Notes for Figure 6H-29—Typical Application 29 Crosswalk Closures and Pedestrian Detours

Figure 6H-29. Crosswalk Closures and Pedestrian Detours (TA-29)

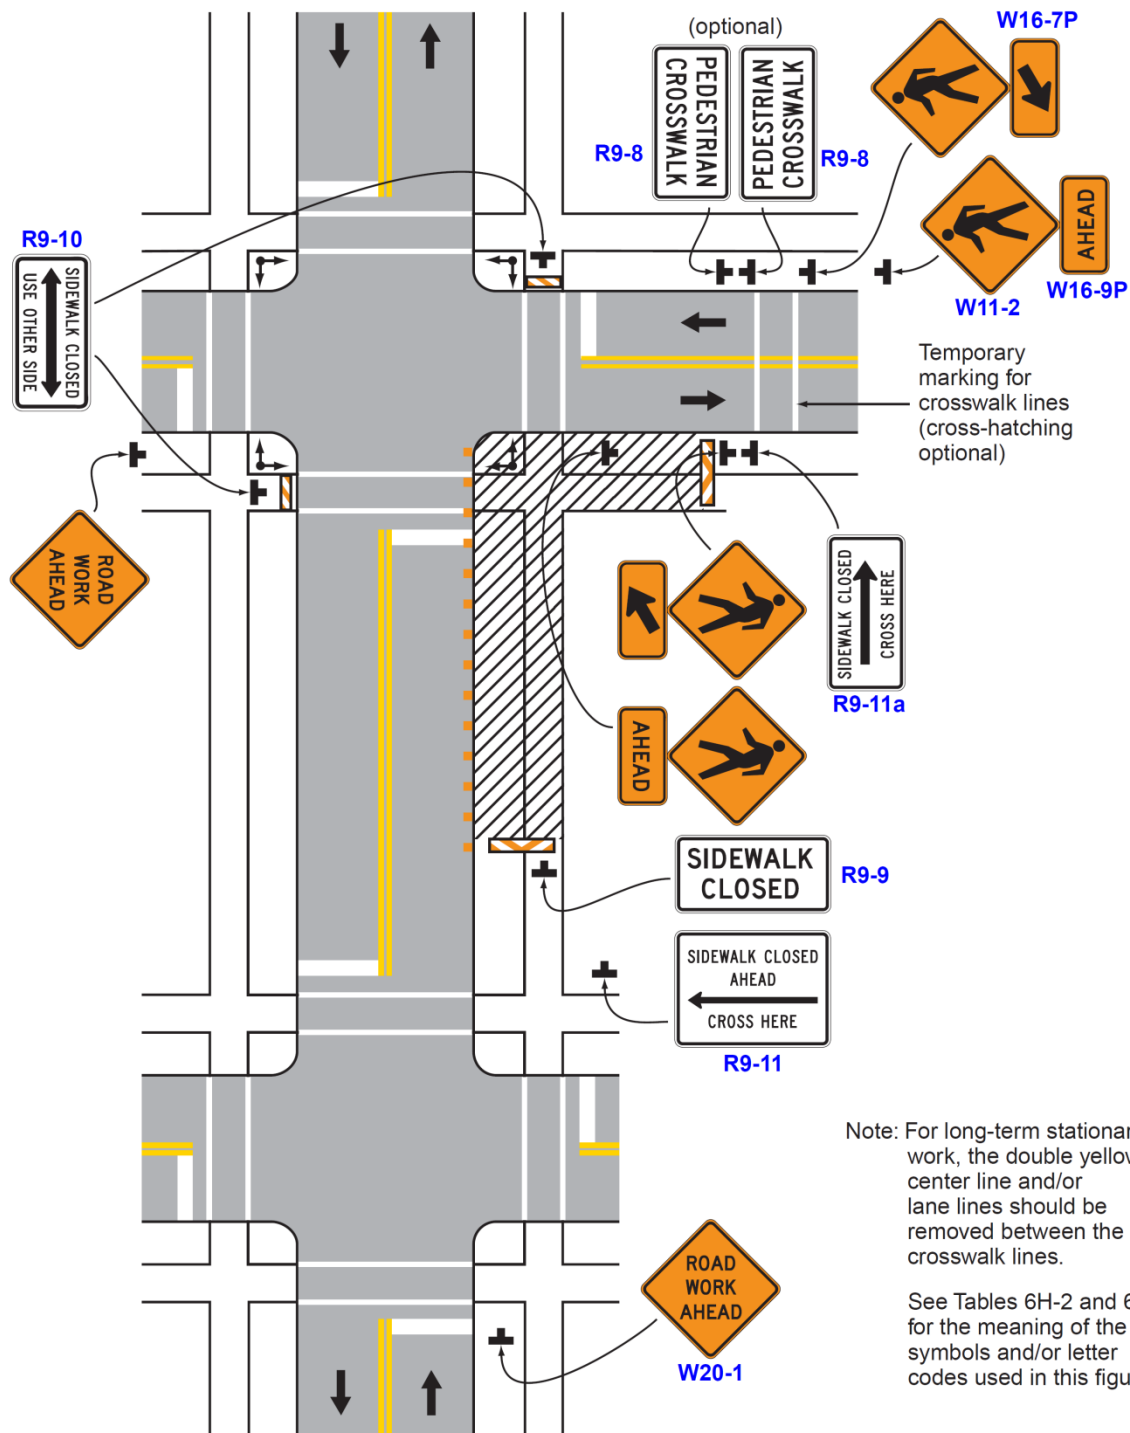
1. When crosswalks or other pedestrian facilities are closed or relocated, temporary facilities shall be detectable and shall include accessibility features consistent with the features present in the existing pedestrian facility.
2. ~~Curb parking shall be prohibited for at least 50 feet in advance of the midblock crosswalk.~~

2. *Parking should be prohibited in advance of mid-block crosswalks. Mid-block crosswalks should be avoided, when possible. See Section 3B.18.*
3. *Audible information devices should be considered where midblock closings and changed crosswalk areas cause inadequate communication to be provided to pedestrians who have visual disabilities.*
4. *Pedestrian traffic signal displays controlling closed crosswalks should be covered or deactivated.*
